ADDENDUM NO. 4 - Date: May 13, 2024

RE: RSD- Relocatables and Playgrounds Replacements at Janson ES

RELOCATABLES AND PLAYGROUNDS REPLACEMENT AT JANSON ES ROSEMEAD SCHOOL DISTRICT

N PLAN NORTH A1.01

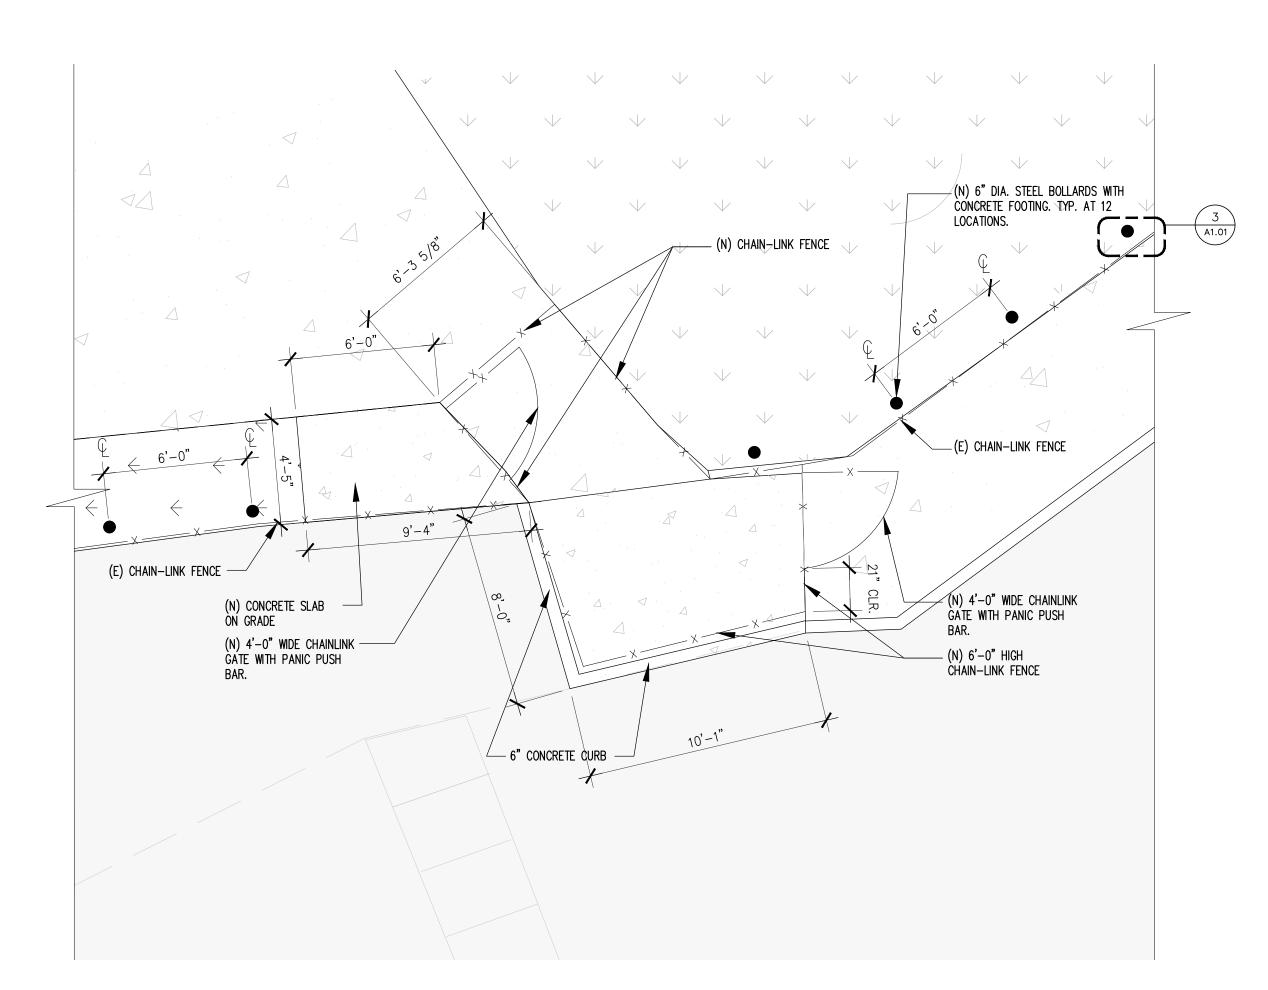
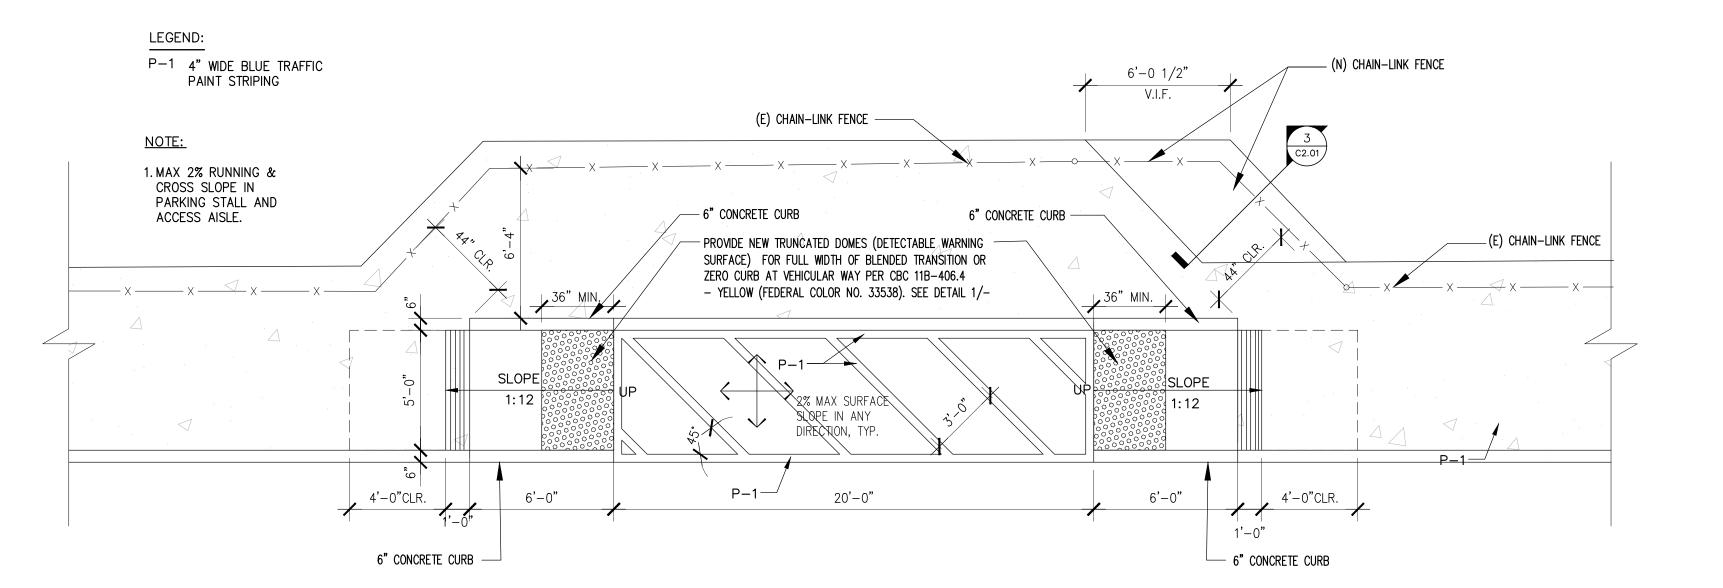
Sheet A1.01 (New sheet)

- 1. New sheet with added scope:
- 1A. Item #1: New drop off loading zone
- 1B. Item#2: Enlarged entry plan indicating new chain link fencing, new chain link fencing gates and new steel bollards
- 1C. Item #3: New steel bollard

A5.00

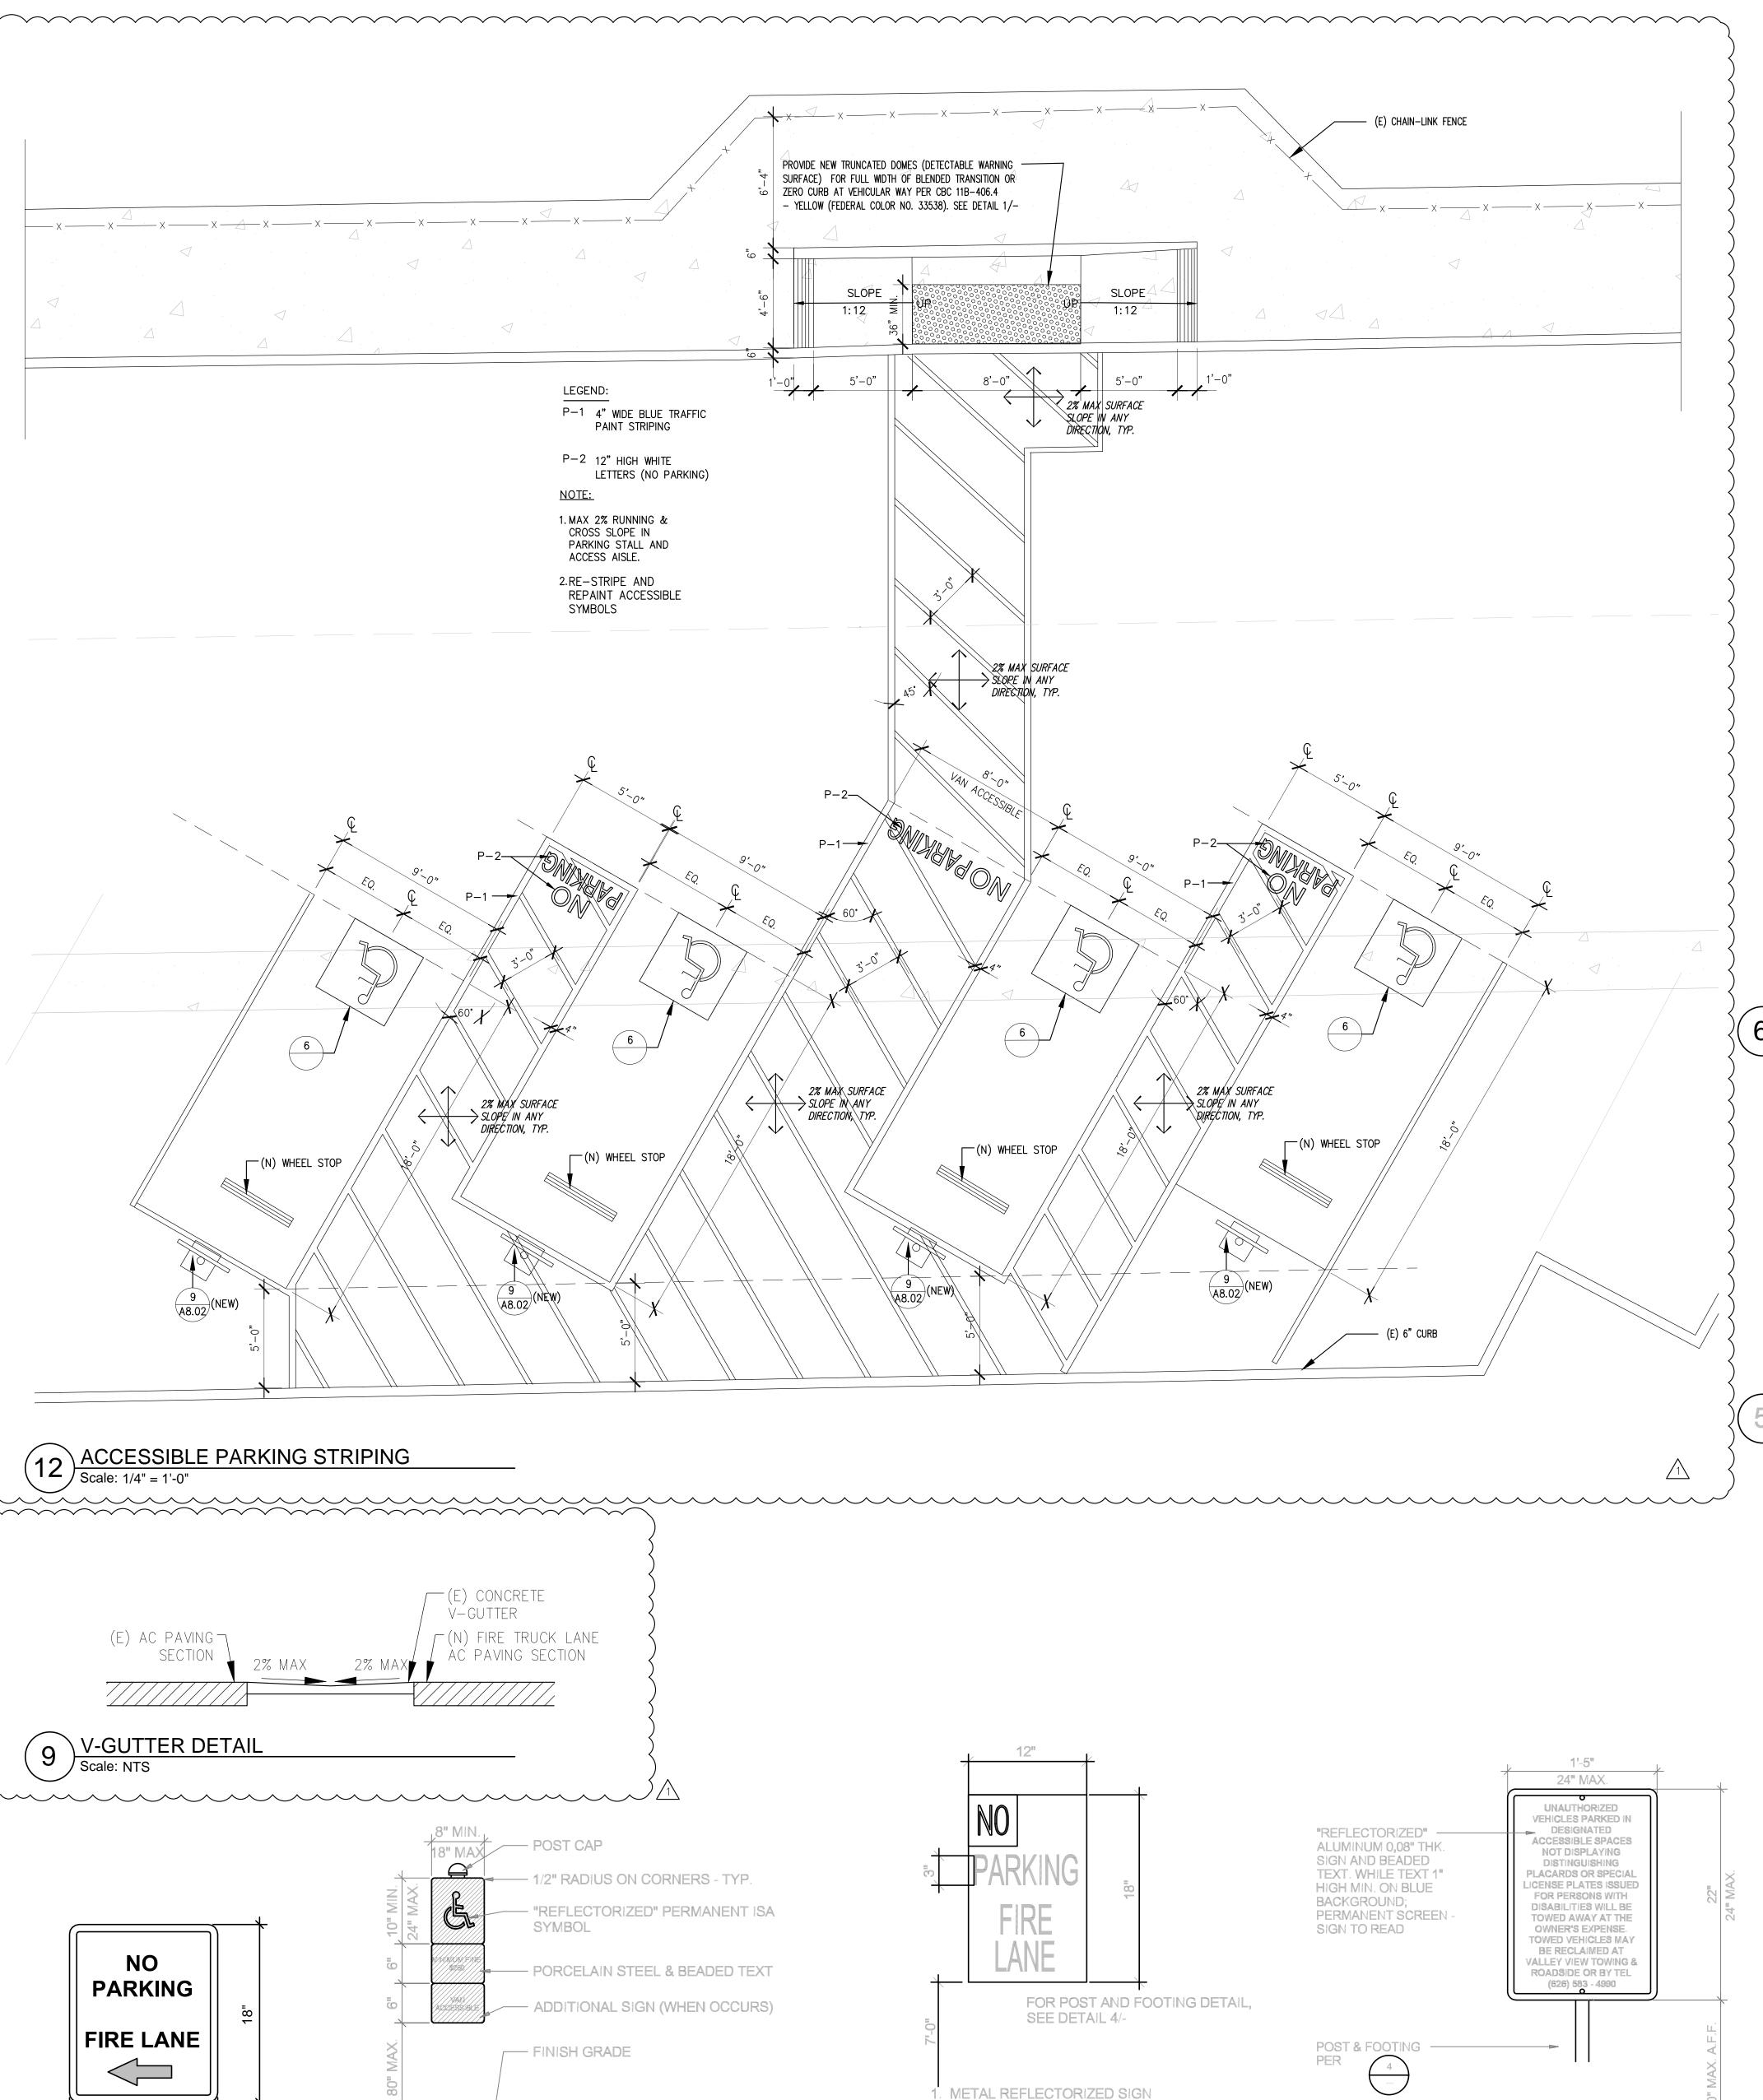
1.Building overhangs and HVAC unit on roof shown as per DSA requirements. No new Bid scope.
Sheet A 5.0
1.Building Exterior elevations added per DSA requirements. No new added Bid scope.
Sheet A 8.02
1.Detail #9 added to show existing gutter, per DSA requirements. No new added Bid scope
2. Detail #12 replaces original detail #9, indicating added ADA scope (striping/truncated domes/signage)
Sheet A 8.04
1.Detail #6 deleted from scope
Sheet A 8.05 (New Sheet)
1.New Sheet indicating new chain link fence, new chain link fence gates and existing wrought iron gate with added hardware and kick plate scope.
JANSON PLAYGROUNDS SET OF DRAWINGS
Sheet G 0.1
1.Scope of work revised per DSA requirements. No new added Bid scope
2. Sheet index revisions. See below for clouded sheet exact revisions

2 CHAIN LINK FENCE ELEVATION, TYP. Scale: 1/2" = 1'-0"

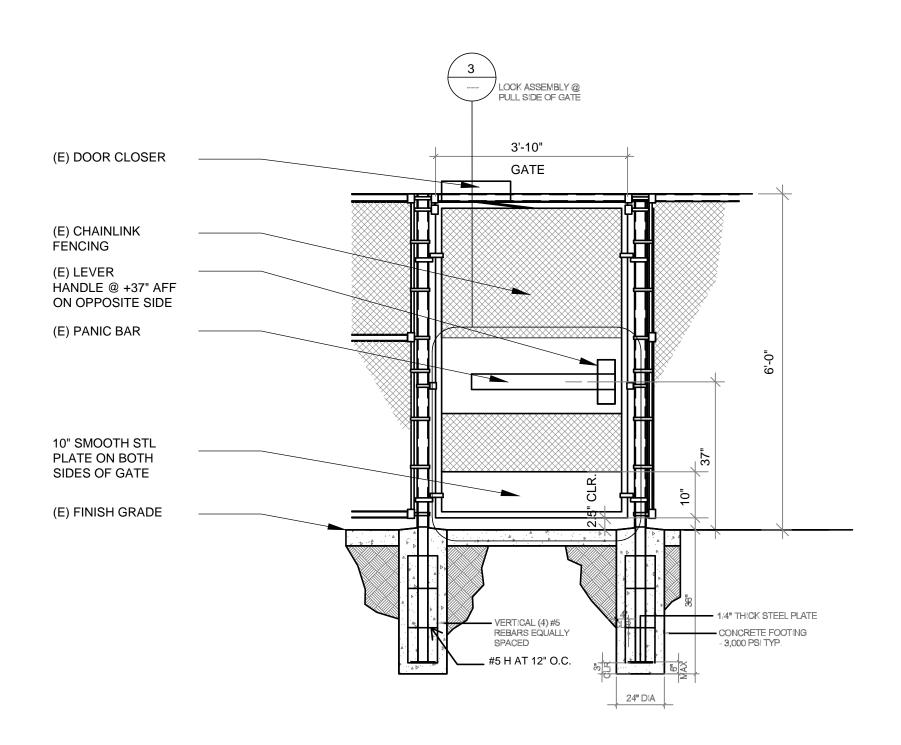
1.Keynotes #4 thru #6 added to indicate new scope for new gates and added new slab on grade
Sheet A8.01
1.Details #4, #7 and #8 deleted from scope. Deleted signage scope
2.Detail #9 revised to #10 indicating additional striping/new truncated domes and additional ADA signage
Sheet A8.02
1.General notes deleted from scope
2. Details #2, #4, #5 and #6 deleted from scope
3. Detail #3- Added new post below ADA signage
4. Details #1 and #2 re-numbered- New new added Bid scope
Sheet A8.05
1.Detail #1: Revised height of chain link fencing to 6' high and added panic bar with backing plate and kick plate
2. Detail #2: Height of C.L. Fencing revised from 4' to 6' high
